**FARRAGUT VISUAL RESOURCES REVIEW BOARD
AGENDA**

MEMORANDUM

TO: Farragut Visual Resources Review Board
FROM: Bart Hose, Assist. Community Development Director.
SUBJECT: Regularly Scheduled Meeting - Tuesday, September 28, 2021, at 7:00 p.m.

b) Marathon Station Ground Sign – 10855 Kingston Pike

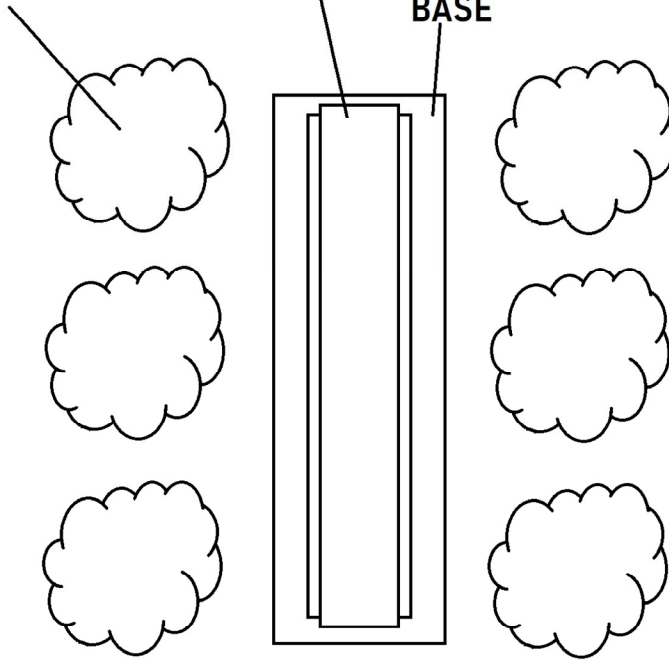
The staff recommends approval subject to the following:

1. The use of decorative split-face concrete block (white) for the sign base, and
2. The use of a dwarf Azalea variety to avoid visibility conflicts with the sign. The shrubs can also be grouped around the ends of the sign to improve visibility.

OLYMPIC DRIVE TRAFFIC ISLAND

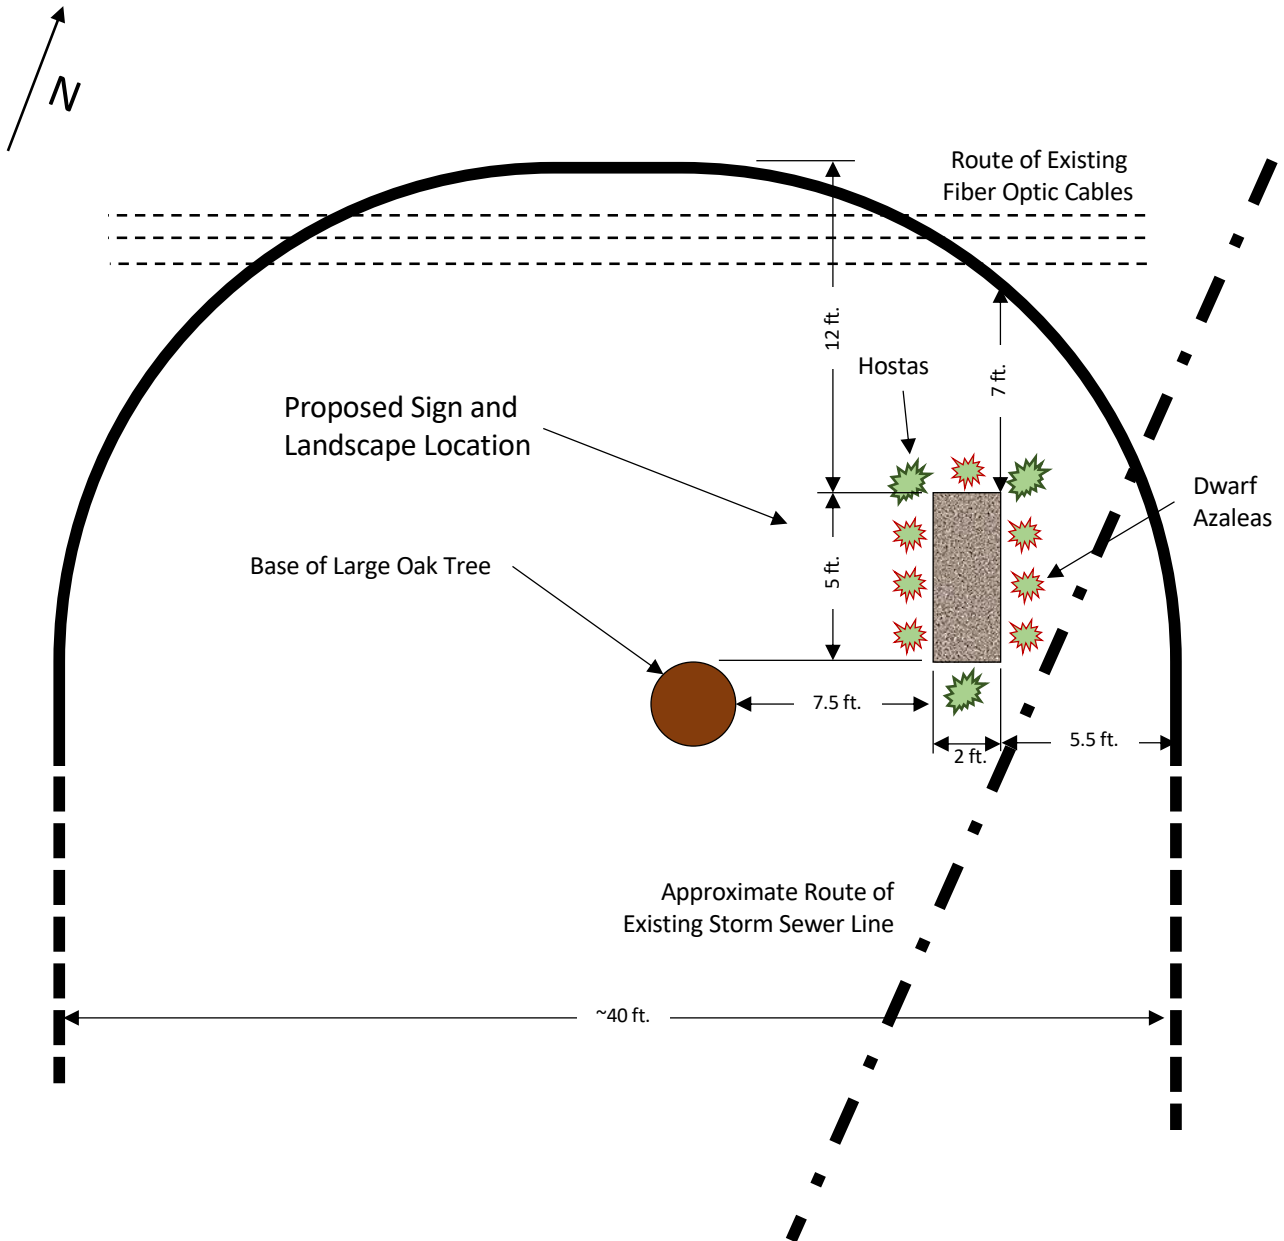
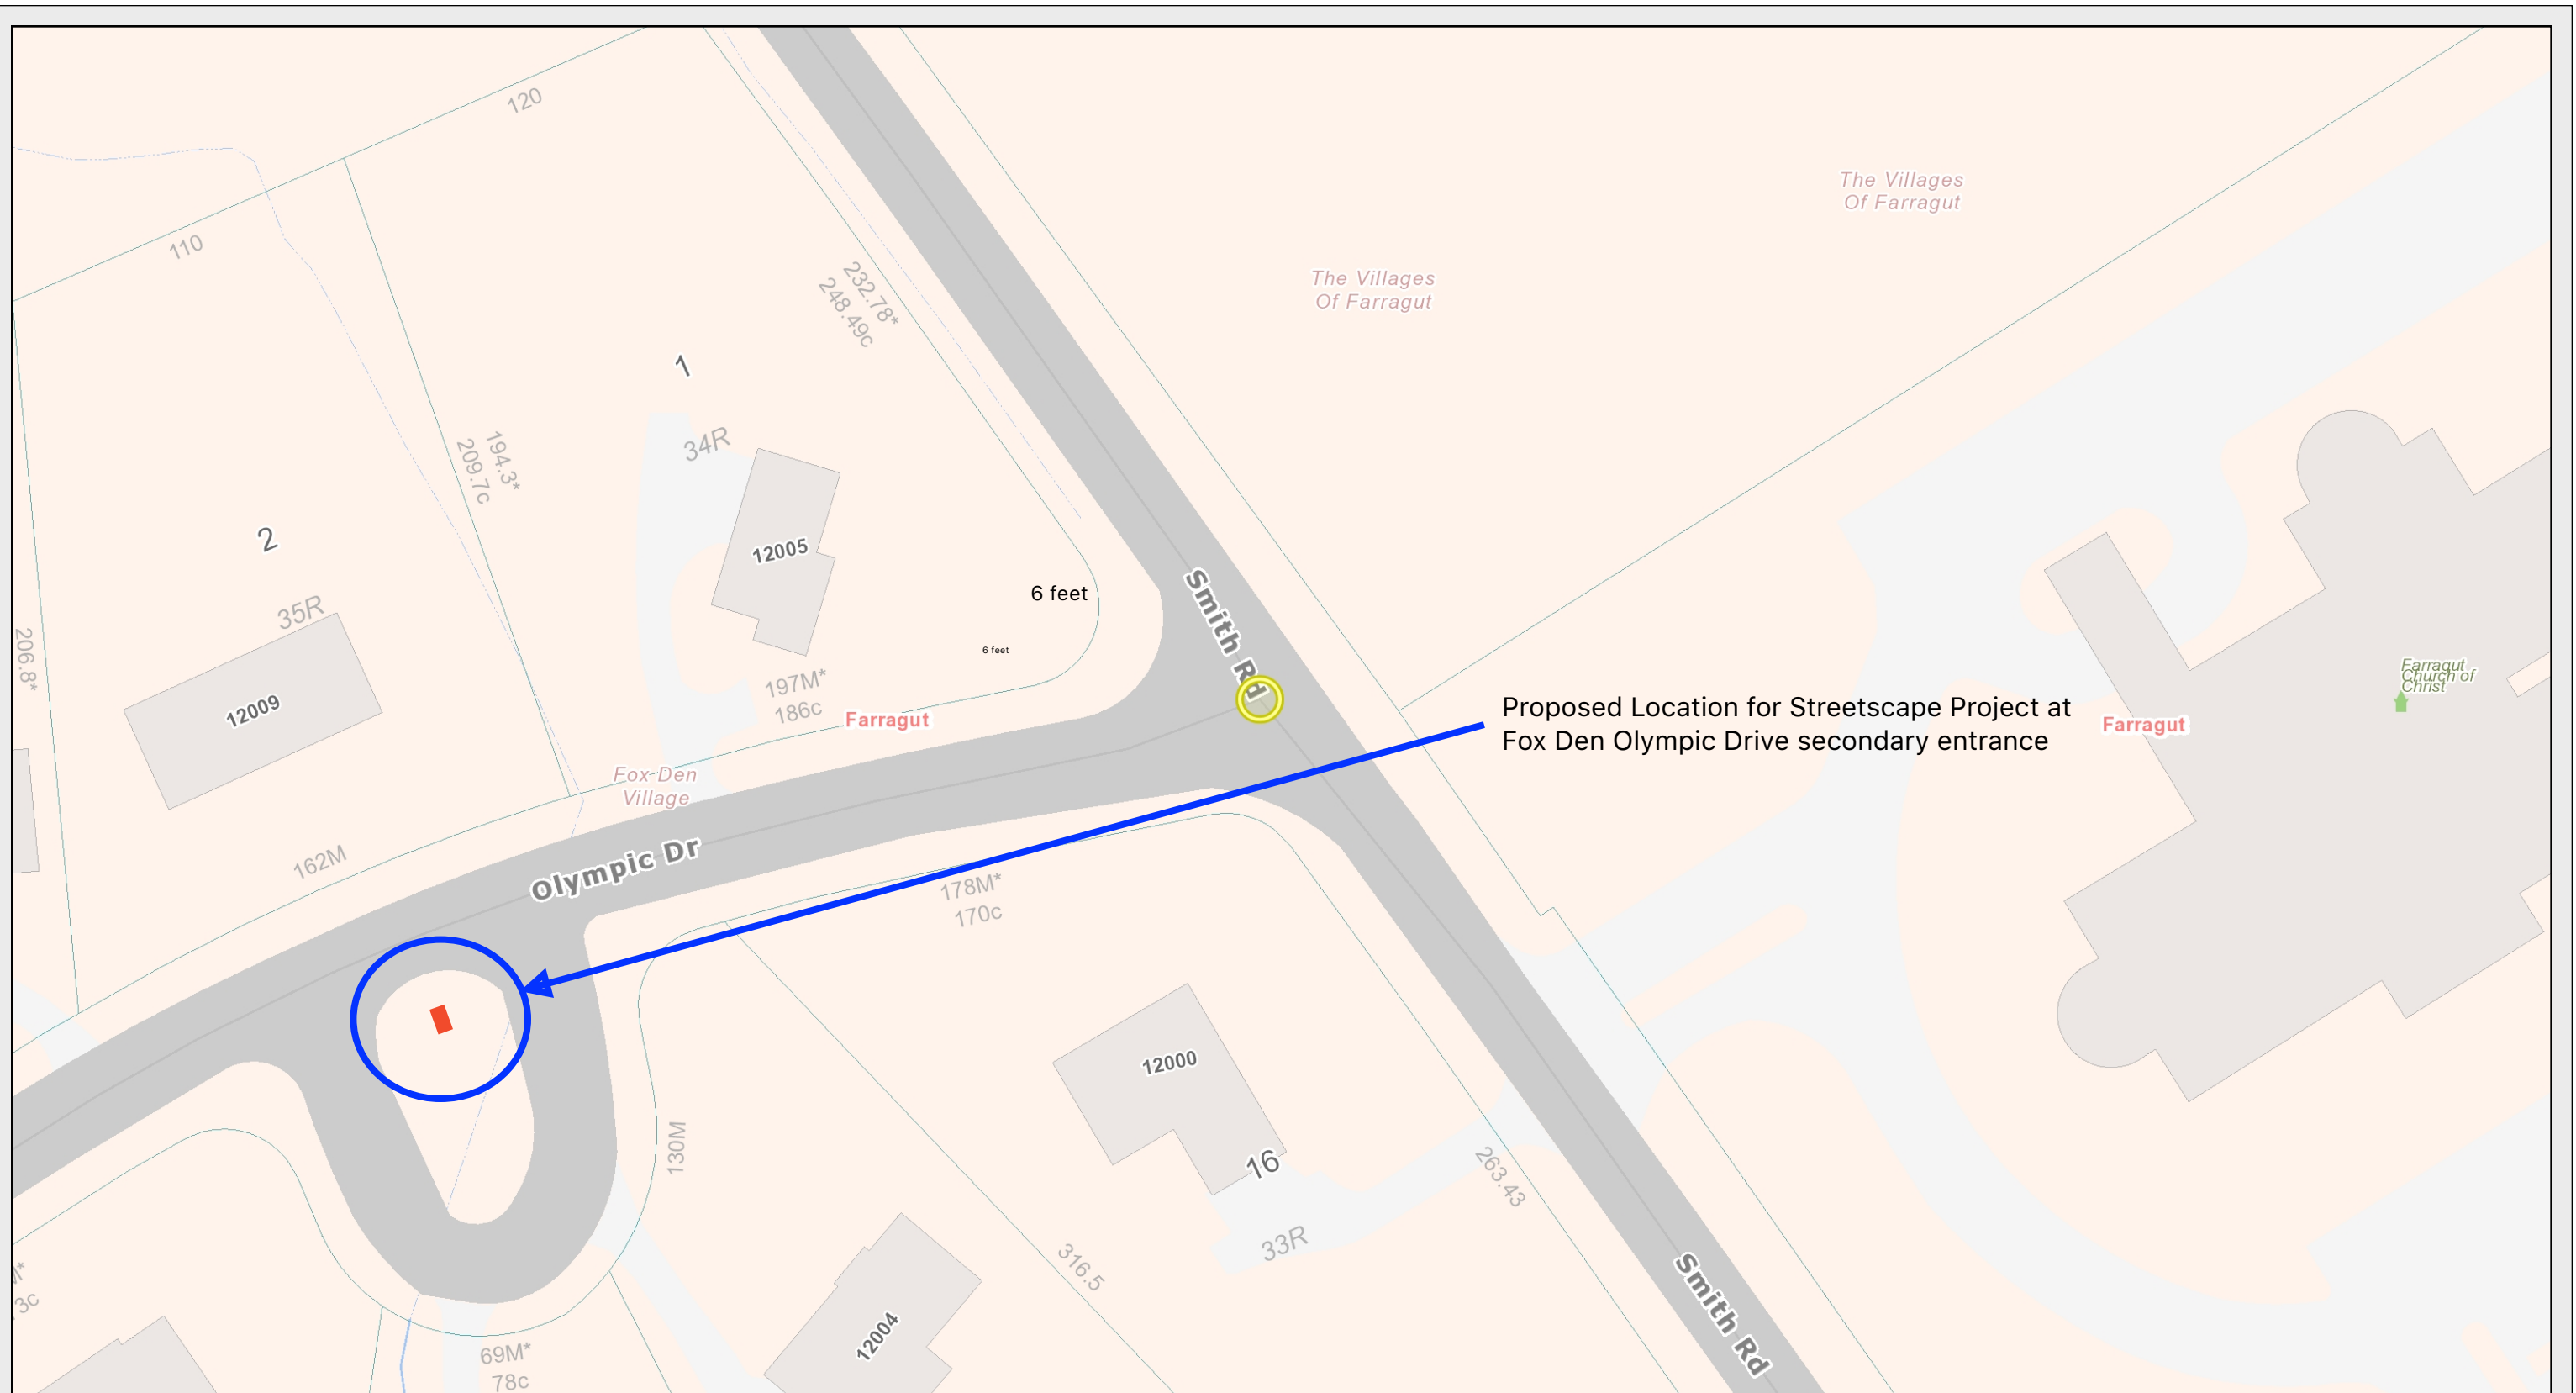
Staff has reviewed the revised plan and has some concerns regarding the sign's proposed location. The HOA has had the existing utilities in the area marked via an 811 call and was forced to revise the original plan and sign location due to the presence of underground communication cables in the ROW. The new sign is now proposed to be located within a couple feet of an existing public storm drainage pipe running through the area. The drainage pipe's location is shown as approximate on the plan but, after looking at the site, the staff believes it is very close. The Town will likely be requiring the HOA to enter into a maintenance and liability agreement, and, under the agreement, the Town will not be responsible for any damage to the sign resulting from public construction/reconstruction related activities in the area. With this agreement in mind, the Town Engineer still felt it necessary to note that drainage infrastructure typically needs to be dug up and replaced periodically and he suggested keeping the sign further away from the pipe, if possible. Site distance at the intersection could also be a consideration if the sign is moved closer to Olympic Drive from its current proposed location. Locating a sign in the ROW is more complicated because utility easements are typically not in place. This means that potential conflicts between any proposed structure and any existing utilities or other infrastructure need to be resolved before permitting and construction.

1. The sign's lettering should be located at least two feet above grade to avoid conflicts with landscaping and improve visibility. The required plantings can also be clustered around the ends of the sign structure to improve visibility.
2. The applicants will need to work with an arborist to ensure that the existing trees are not damaged during sign installation.
3. A maintenance and liability agreement to protect the public right-of-way and other Town interests will need to be put in place. The Town's attorney will also likely suggest that an easement for the sign be identified which may require a survey.

ST. ANDREWS DRIVE TRAFFIC ISLAND

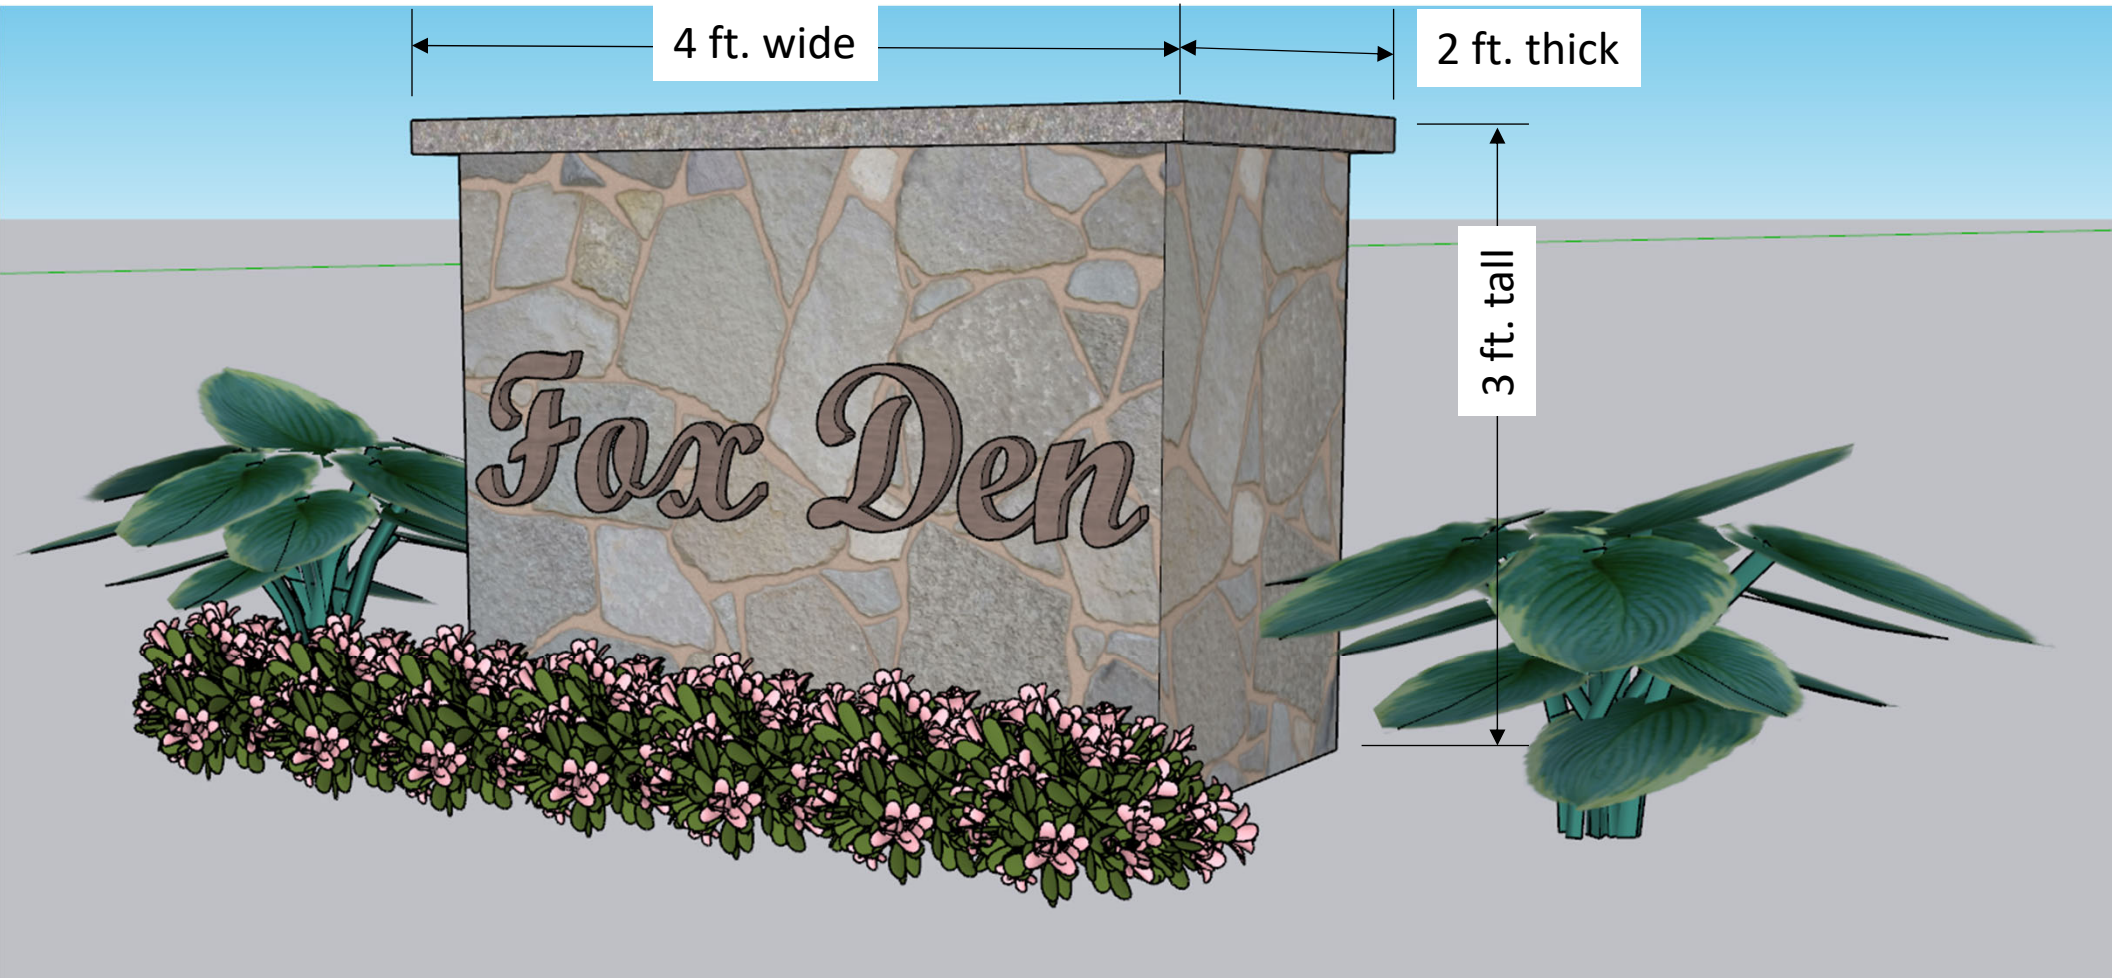
The staff has reviewed the revised plan and also has some concerns regarding the sign's proposed location. The HOA has had the existing utilities in the area marked via an 811 call and was forced to revise the original plan and sign location due to the presence of an existing water main in the ROW. The new sign is now proposed to be located two feet from an existing gas line running through the area and three feet from the edge of curb. The minimum two feet of separation from the gas line was based on guidance from the 811 system. Staff has discussed this with the Town's Engineer, and he noted that it is a typical minimum recommendation based on their (811's) margin of error when locating utility lines. The Town will also likely be requiring the HOA to enter into a maintenance and liability agreement, and, under the agreement, the Town will not be responsible for any damage to the sign resulting from public construction/reconstruction related activities in the area. This would protect both the Town, and the gas utility's access to the line, but it is still a very tight site location. As previously noted, locating a sign in the ROW is more complicated because utility easements are typically not in place. Potential conflicts between any proposed structure and any existing utilities or other infrastructure need to be resolved before permitting and construction.

1. The sign's lettering should be located at least two feet above grade to avoid conflicts with landscaping and improve visibility. The required plantings can also be clustered around the ends of the sign structure to improve visibility.
2. The applicants will need to work with an arborist to ensure that the existing trees are not damaged during sign installation.
3. A maintenance and liability agreement to protect the public right-of-way and other Town interests will need to be put in place. The Town's attorney will also likely suggest that an easement for the sign be identified which may require a survey.

NEW MENU BOARDS

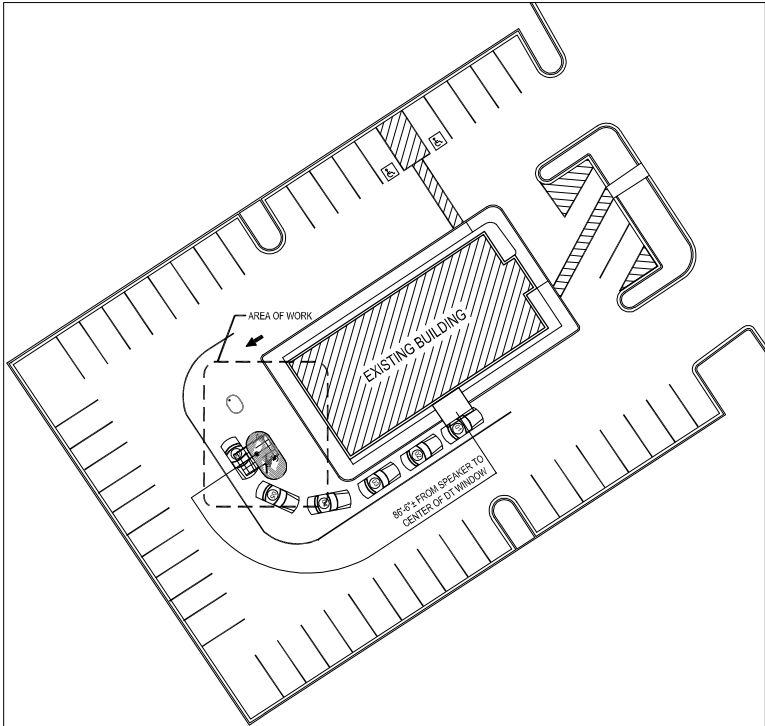
The plan includes a new, approximately 25 square foot drive-thru menu board. The new sign will replace the current menu board on the site and includes an ancillary order box and a covering canopy. The canopy structure will require a building permit and will need to be permitted separately. The new menu-board is part of a larger external renovation project on the site. Unfortunately, some of the renovations and site changes were begun without adequate plan submittal, review, and approval. The Town staff has been attempting to address the situation with a local representative for the project but there are still outstanding issues. This item was placed on the VRRB agenda so the menu board could be reviewed while we/they are working to address the other issues on the site. No permits will be issued until the Town has received adequate plans for all of the proposed site renovations and those renovations have been reviewed and approved.

With respect to the menu board sign and related speaker box, they meet the Town's minimum standards and can be approved subject to all other site renovations/improvements being brought into compliance with Town requirements.
